**Comments on Application for Variance or Appeal filed on behalf of Cornell by
Thomas D. Hoard, HOLT Architects, P.C., dated 13 September 2013**

Submitted by Jonathan Ochshorn, Oct. 10, 2013

Milstein Hall is an addition to both Rand and Sibley Halls on the Cornell University campus in Ithaca, NY that created a single building, Rand-Sibley-Milstein Hall. A certificate of occupancy was issued on Feb. 24, 2012. The variance application submitted by Thomas Hoard on behalf of Cornell University to place a noncompliant library assembly occupancy on the second and third floors of Rand Hall (part of Rand-Sibley-Milstein Hall) should be seen in the following context:

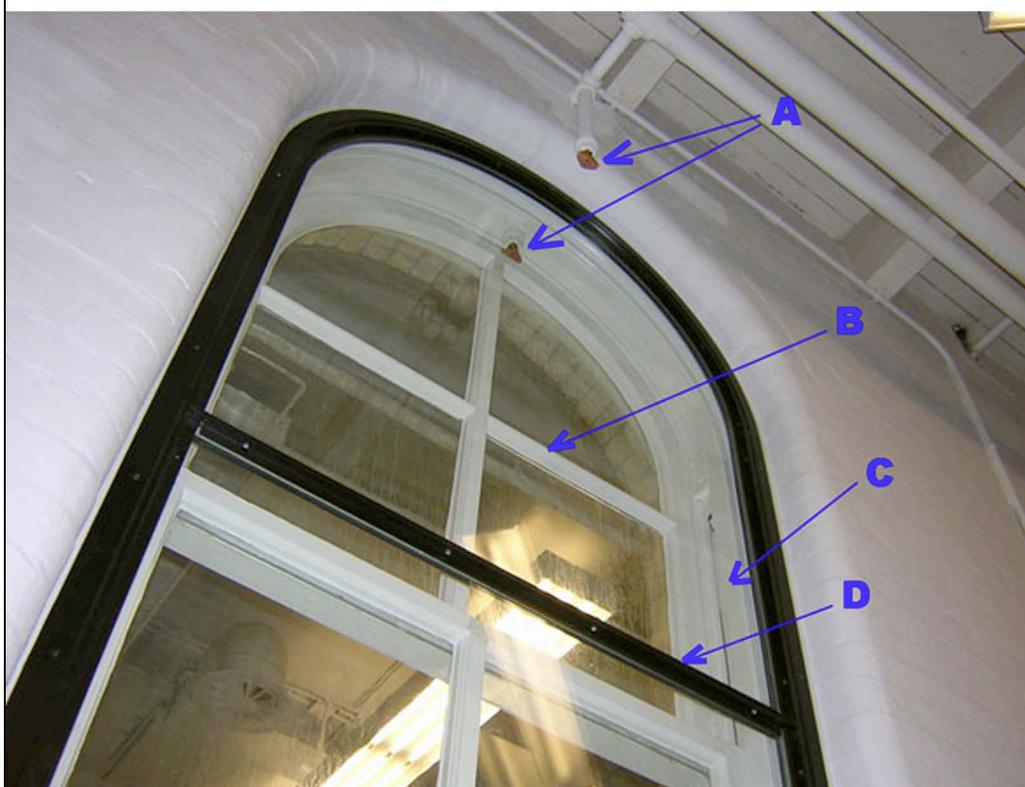
First, the fire barrier between Milstein and Sibley Hall at the second-floor level does not meet the minimal requirements for a 1-hour fire-rated wall under the 2002 BCNYS – Cornell admitted in testimony at the Hearing for Petition No. 2013-0250 that opening protectives for window areas, in excess of the allowable 25% aggregate width limit, were covered with 3/4-hour fire-resistance rated glazing instead of the required 1-hour fire-resistance rated glazing. An attempt to remedy this error by providing Tyco Model WS Specific Application Window Sprinklers was conditionally approved by the Review Board at the Hearing for Petition No. 2013-0250 (Exhibit 3), subject to a "submittal from the City of Ithaca on the testified approvals from the compliance testing lab." The submitted document, incredibly, contains the same NER-516 "Legacy Report" that Cornell had already referred to at the Hearing – a report that specifically *prohibits* the use of Tyco sprinklers in the way that Cornell used them. As shown in Figure 2 below, this system is noncompliant if the glazing has intermediate horizontal mullions, *or* if combustible material is within two inches of the glazing. The Sibley-Milstein fire barrier openings fail not only one of these tests, but fail both of them. In other words, the petitioner is requesting a variance to *leave existing fire barriers in place*, rather than

upgrading the Rand-Milstein fire barrier per the requirements for changes of occupancy under the 2010 EBCNYS, yet even the minimal standards for a 1-hour fire-resistance rating, mandated by Section K902.2 of the 2002 BCNYS, have not been complied with.

Figure 2. Fire-rated glazing with special Tyco sprinklers (bottom image, photo by J. Ochshorn) does not meet the requirements for a 1-hour fire-resistance rating outlined in the NER-516 "Legacy Report" submitted by Cornell; the system as installed by Cornell has intermediate horizontal mullions (labeled as "D" in the photo) and combustible material within two inches of the glazing (labeled as "C" in the photo), either of which render the entire assembly noncompliant. The specific NER-516 requirements are reproduced at the top of the figure.
